360-degree Fisheye Camera Installation for Double Panorama

Updated: November 17, 2021

Panasonic i-PRO Sensing Solutions Co., Ltd.

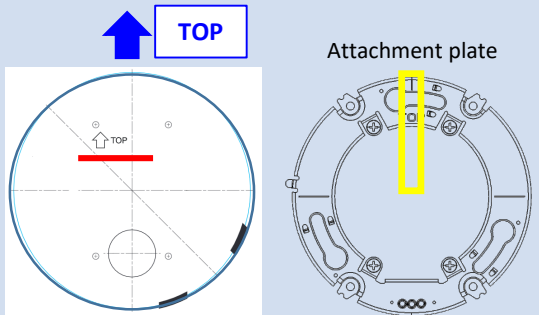
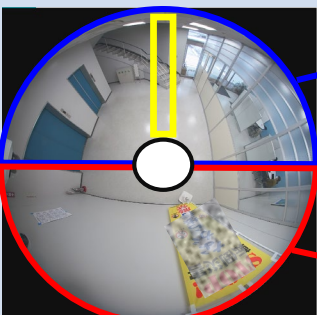
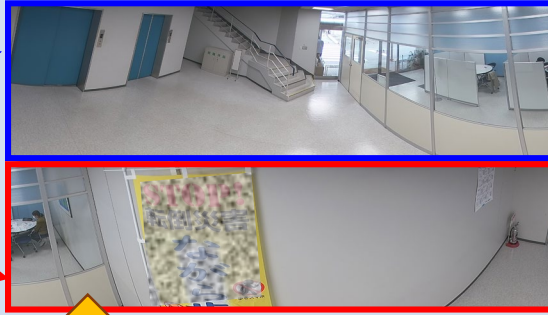
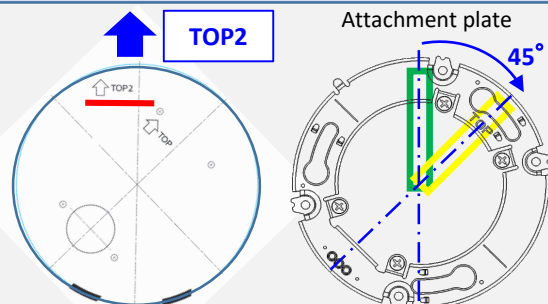
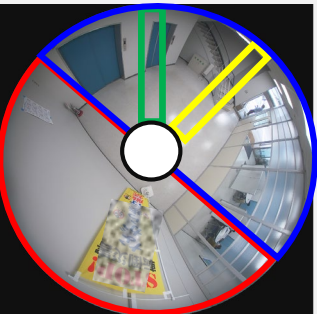
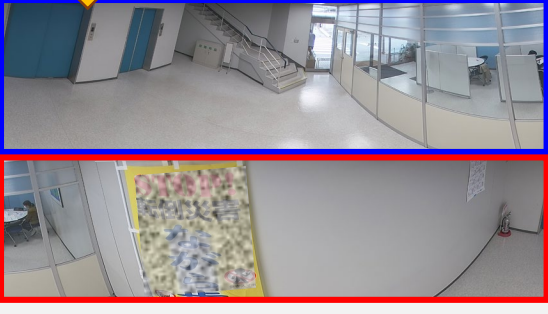
When "Double panorama" is selected for [Image capture mode] in the above applicable models, the center of its image will be shifted by 45 degrees compared to the conventional models. Therefore, it is necessary to shift the camera in advance by turning the attachment plate 45 degrees at installation, as shown on the next page. (Position adjustment in units of 90 degrees is possible after installation)

Approx. 45 degrees shifted from the center

Installation	In Fisheye mode	In Double panorama mode
<p>Conventional models</p> <ul style="list-style-type: none"> WV-X4170 WV-X4171 WV-X4571L(M) WV-S4150 WV-S4550L(M) WV-SW458MA 	 <p>Attachment plate</p>	 <p>Top image</p> <p>Bottom image</p>	
<p>Applicable models</p> <ul style="list-style-type: none"> WV-X4173 WV-S4151 WV-S4551L(M) WV-X4172 WV-X4573L(M) WV-S4156 WV-S4556L(M) WV-S4176 WV-S4576L(M) <p>Align "TOP2" with the upper direction of the screen at installation. The same applies to when using a base bracket for outdoor models.</p>	 <p>Attachment plate 45°</p>	 <p>Image turns 45 degrees to the right</p>	 <p>Same image as conventional model</p>
